The Commission has issued the enclosed Amendments Nos. 39, 37 and 13 to Facility Licenses Nos. DPR-33, DPR-52 and DPR-68 for the Browns Ferry Nuclear Plant, Units Nos. 1, 2 and 3. These amendments consist of changes to the Technical Specifications in response to your request of May 17, 1978 (BFNP TS 109) regarding implant electrical system modifications as described in your letter of May 2, 1978. With your concurrence, we have modified the Technical Specifications to more specifically describe the equipment affected by the modifications.

BROWNS FERRY NUCLEAR PLANT, UNIT NO. 1

AMENDMENT TO FACILITY OPERATING LICENSE

BROWNS FERRY NUCLEAR PLANT, UNITS NOS. 1, 2 AND 3

Figure 1

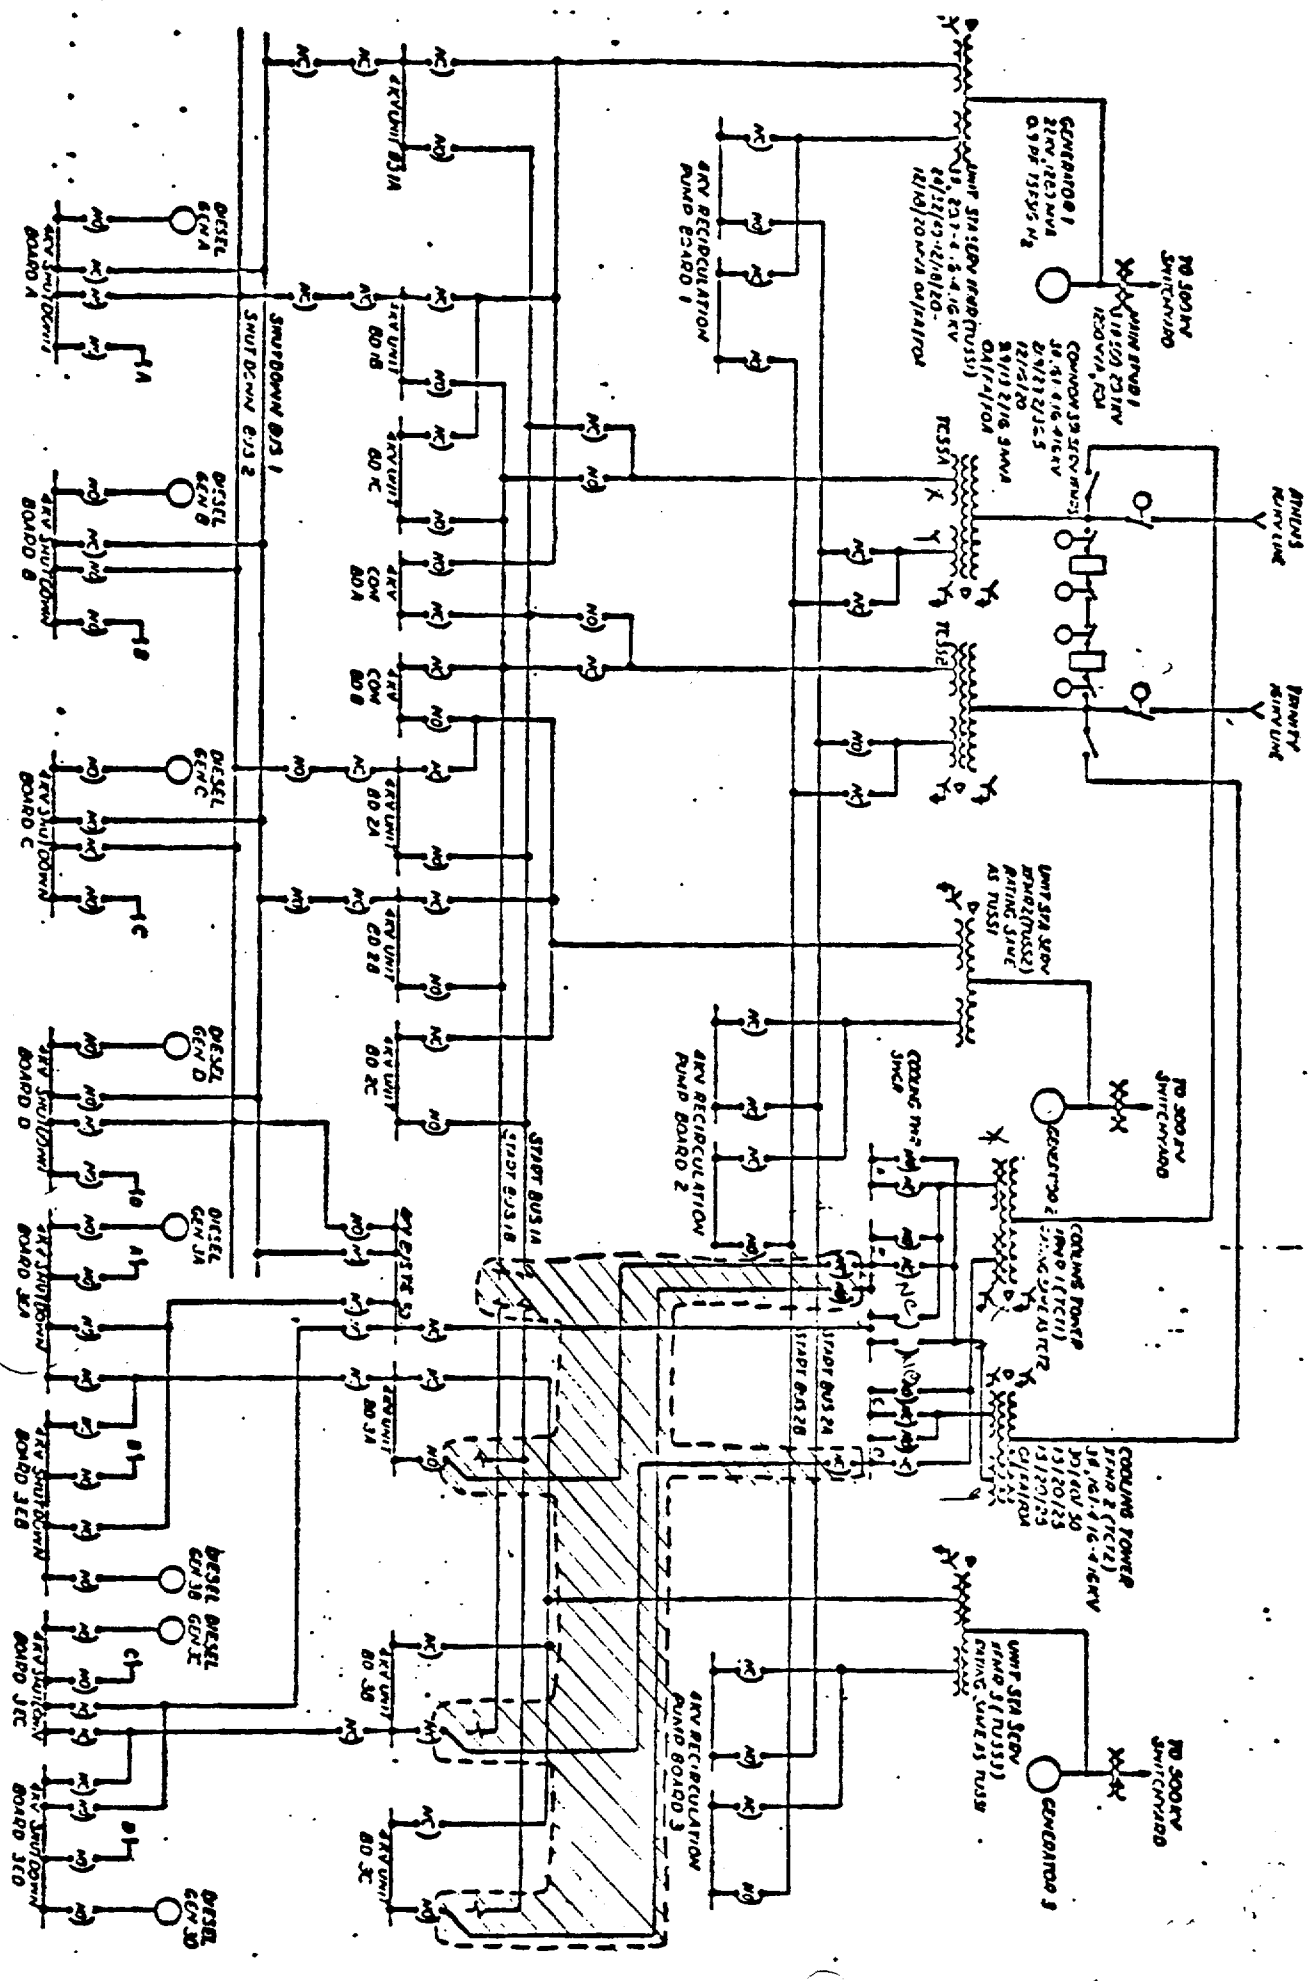
The system modifications to correct the inplant system undervoltage consist of: (a) installation of capacitor banks at the Browns Ferry terminal ends of the two 161 kV transmission lines to improve the power factor and (b) rearranging the 4160 volt loads of Unit 3 to reduce the voltage drop due to high impedance in common station service transformers.

Unit 3 boards 3A, 3B, and 3C will be cut off the start bus 1A and 1B and will be supplied from cooling tower transformers 1 and 2 as shown in the cross-hatched portion of Figure 1. The offsite supplies for shutdown boards 3EA and 3EB, and for shutdown boards 3EC and 3ED are fed through board 3A and 3B, respectively. The 4kV bus tie board can be supplied power by either of the cooling tower transformers and remains unchanged from the original design.

The feeder cables for these offsite power supplies are routed in separate cable trenches to the cooling tower transformers. The system modifications also improve the power factor on the offsite power source by installing the capacitor banks on 161 kV line, and reduce the voltage drop on the inplant system by rearranging the 4160 volt loads to common station service transformers and cooling tower transformers. The modified configuration would result in a voltage of 3950 volts on 4160-volt inplant system for the postulated events.

The staff has reviewed the licensee's proposed modifications to the plant system - the installation of two capacitor banks and the rearrangement of the Unit No. 3 4160 volt loads to improve the inplant system voltage. The staff also reviewed the associated changes to the Technical Specifications resulting from these modifications. Based on the evaluation of the information provided by the licensee, the staff concludes that the proposed system modifications are an acceptable method of assuring that the inplant system voltages satisfy the requirements of General Design Criterion 17 with regard to system capacity and operability. With the changes we have proposed and which the licensee has accepted, the staff finds the changes to the Technical Specifications to be acceptable.
